Memorandum

To: Sussex County Planning Commission Members
From: Jamie Whitehouse, Director, Department of Planning & Zoning; Lauren DeVore, Planner III, Jenny Norwood, Planner I, Christin Headley, Planner I, Nicholas Torrance, Planner I, and Chase Phillips, Planner I
CC: Vince Robertson, Assistant County Attorney
Date: October 27, 2020
RE: Other Business for the November 12, 2020 Planning Commission Meeting

The Estuary – Phase 3 (2005-64)

Final Subdivision Plan

FINAL SITE PLAN

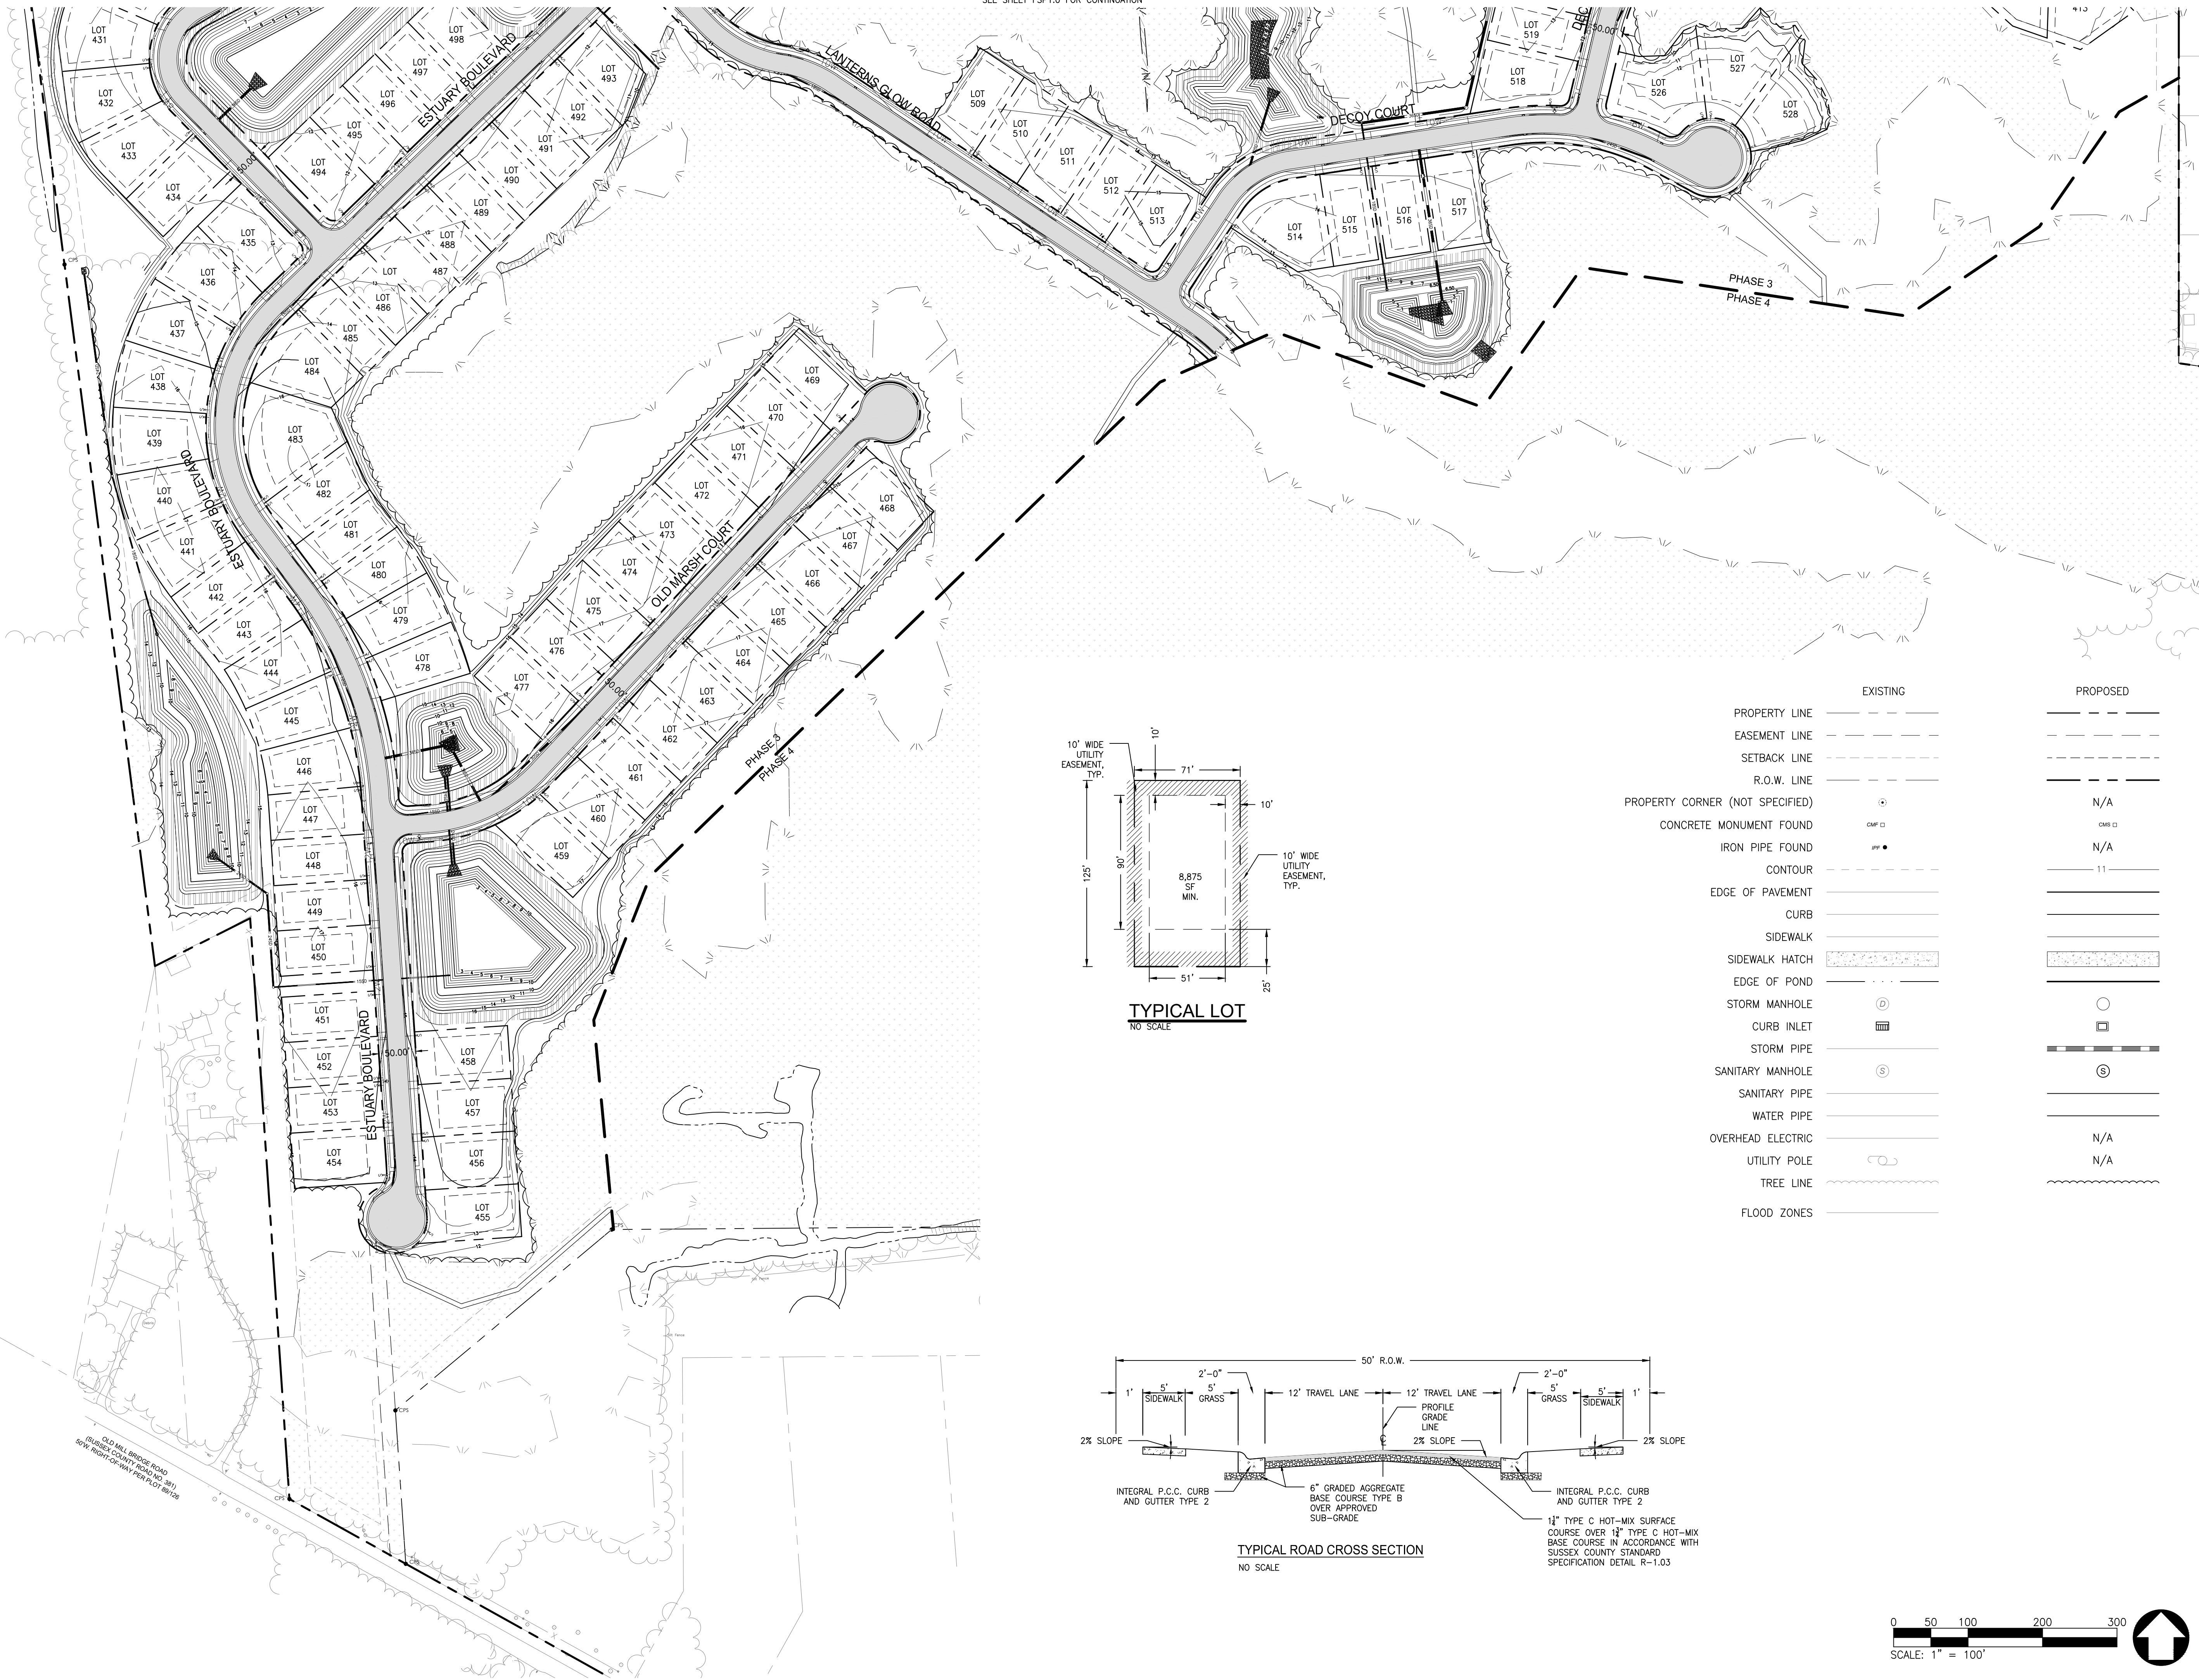
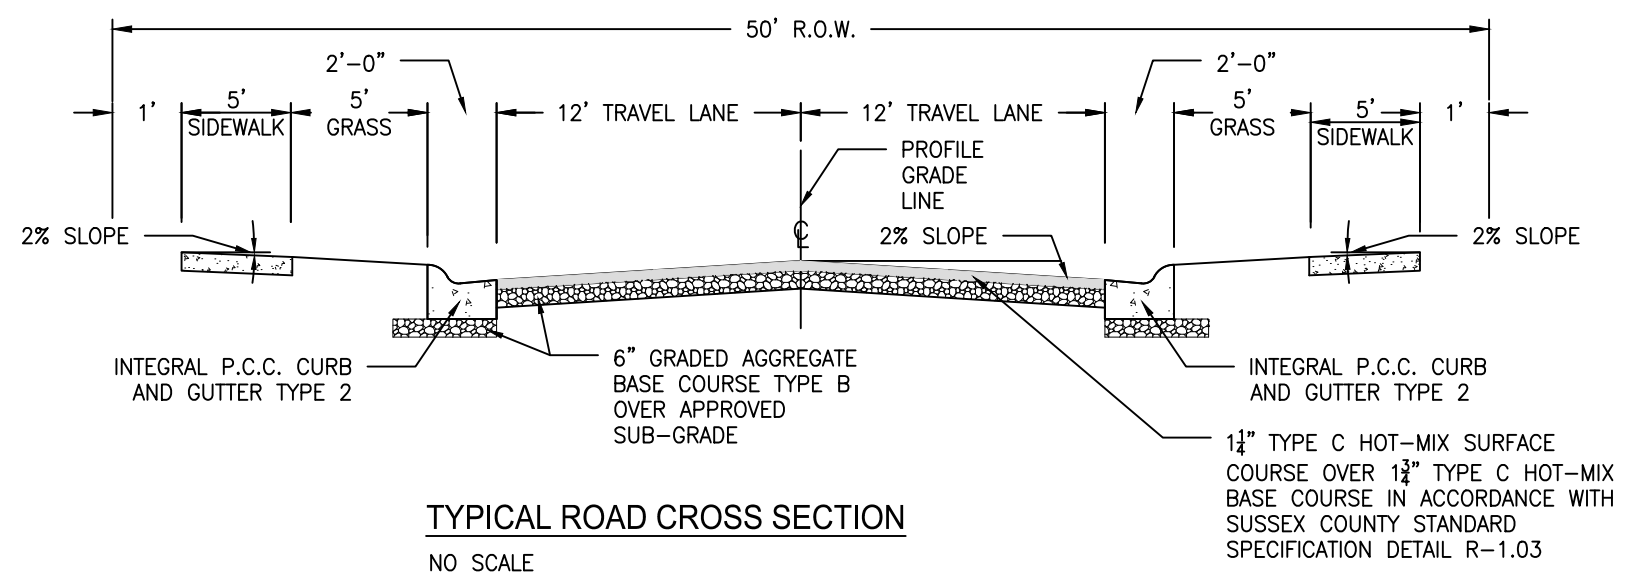
- Comment 9: Please add hatching or symbology which clearly indicates that sidewalks will be provided in the community to accord with Condition #13 of the Conditions of Approval.

- Comment 11: Please include a typical street section of the street construction design in the plans (§99-26(A)(12)).
Response 11: *County standard street sections are now indicated on the recently added Final Site Plans, sheets FSP1.0 and FSP1.1*

Response 9: *Sidewalks will be constructed as part of the subdivision streets and are now shown on the recently added Final Site Plans, sheets FSP1.0 and FSP1.1, as well as the typical road crossing section on FSP1.0 and FSP1.1.*
